Appl. No. 10/538,914 Amdt dated July 21, 2006 Reply to OA of March 23, 2006

Description of Amendments to the Drawings

REMARKS

PRIOR ART

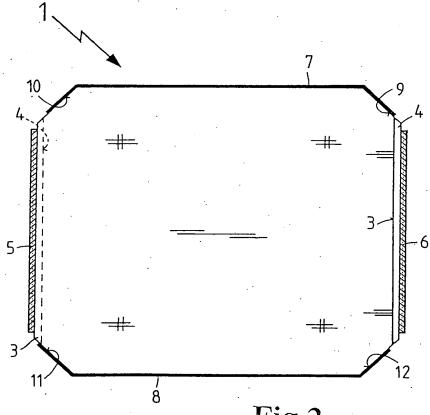
By the attached replacement sheet of drawings, figure 1 has been amended by labeling it as prior art.

The examiner has objected to the drawings for failing to identify Figure 1 as Prior Art. In response to the examiners objection to Prior Art Figure 1, Figure 1 has been amended to include the term "Prior Art".
